HISTORIC LANDMARK COMMISSION STAFF REPORT

Petition #PLNHLC2009-00385 Willmore Remodel

Address: 175 North Virginia Street

Type of Request: Major Alteration

Attachment B Proposed Elevations

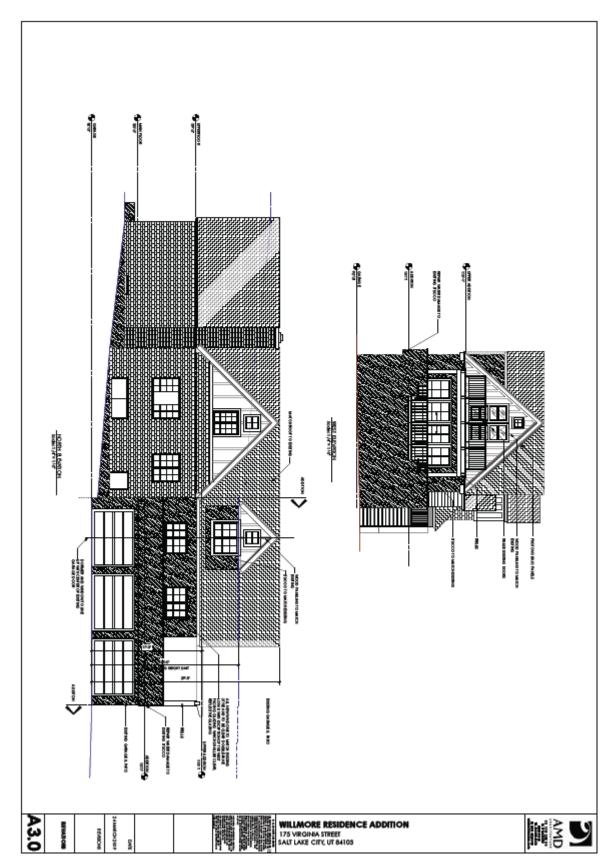
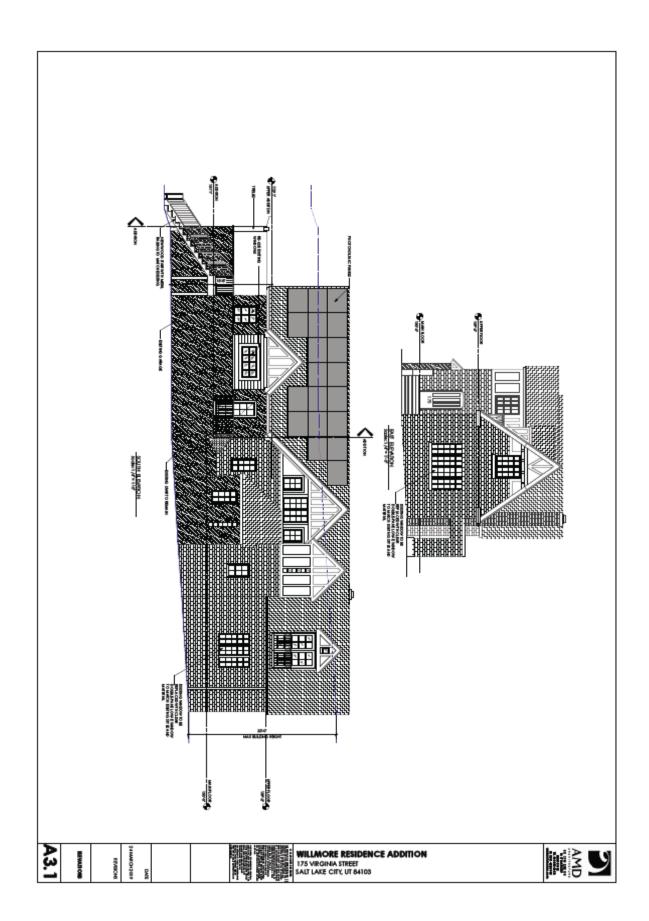
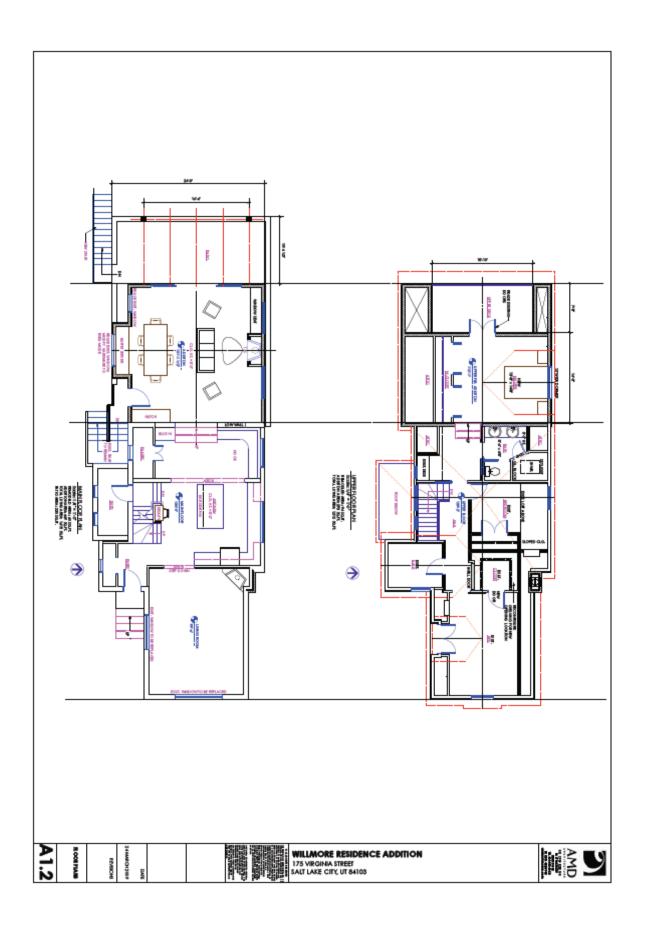
The applicant would like to build an addition and to replace the windows that were not replaced as part of the 2004 remodel. Central to the project is the height of the addition. The proposed roof line merges with the existing roof line of the contributory structure. Nonetheless, because of the downhill slope of the lot, the height of the building is greater in the rear (29' 5") than in the front (24' 6"). Section 21A.24.080.D of the Salt Lake City Zoning Ordinance states:

Staff applied the proposed addition to this requirement and found that although the ridgelines of the addition and primary structure are in line, the down hill slope of the property makes it unclear as to whether or not the height would meet the "average height" of the principal buildings on the block face. It was then determined that the best course of action would be Historic Landmark Commission review under section 21A.34.020 of the Zoning Ordinance.

Discussion: The project meets the all of the minimum requirements for this zoning district with the exception of maximum building and wall height. Section 21A.24.080.D.6 of the Zoning Ordinance allows the HLC to grant height exceptions in historic overlays. The proposed height matches the existing house. The abutting property is two stories, as are all the buildings on the block face. There are multiple two-story houses in the neighborhood.

Analysis: The design of the addition contemplates an extension of the ridge line of the main home, built in the same style with the same roofing materials. Nevertheless, the structure is distinguishable from the contributory section of the home through a change in setback of the structure, and changes in the type of material proposed (contemporary stucco vs. painted brick).

Analysis: The design of the roof over the addition is designed to match the size, style and shape of the existing historic roof. There is a clear line delineating the new from the old, and the historic mass, footprint and scale are protected. The design of the addition is compatible with the existing contributory structure and will be located away from the primary architectural features of the historic front façade. The proposed window replacements are inappropriate and staff recommends that they not occur (see staff analysis above). No changes to the original siding, stucco or finish work are proposed as part of this application.

The proposed roof mounted solar panels are located in the rear of the building on the roof of the addition. They are proposed to be lower than the primary ridgeline and will be attached along the roof plane.

- 5. The maximum height of the primary ridge of the addition shall not exceed 29.5 feet above finished grade (existing grade at the time this application was submitted).
